## SB, Wheel binding, Powermax 42 & 36 E/A Li, 2012-06

All Powermax 42 & 36 E /A Li models produced after W50 2009.

**Product numbers:** 4037,4043, 4035 & 4041

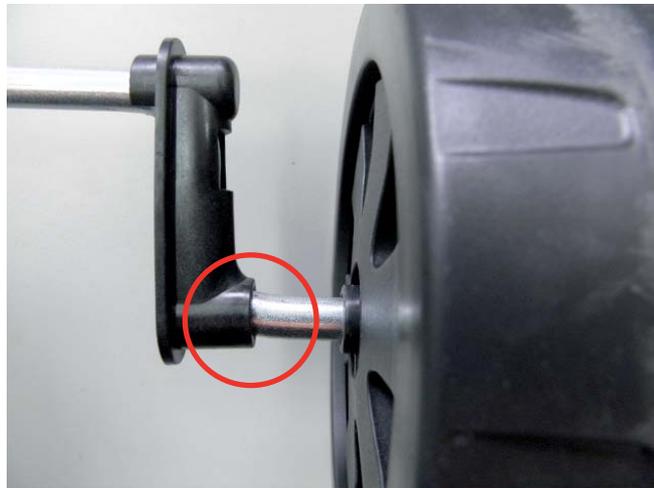
We have observed some customer returns due to complaints that the wheels does not run smoothly while using the lawnmower. Problem arises when wheel is pushed against inner part of wheel axle and then binds on the radius of the axle.

**Field fix:** For products already on market a fix were a washer and new starlock washer is added helps the problem. A permanent fix will be implemented in production as soon as possible.

Article numbers of parts used for field fix **Washer: 5811571-01, Starlock: 5149680-00**, 1 washer and 1 starlock per wheel axle is needed.
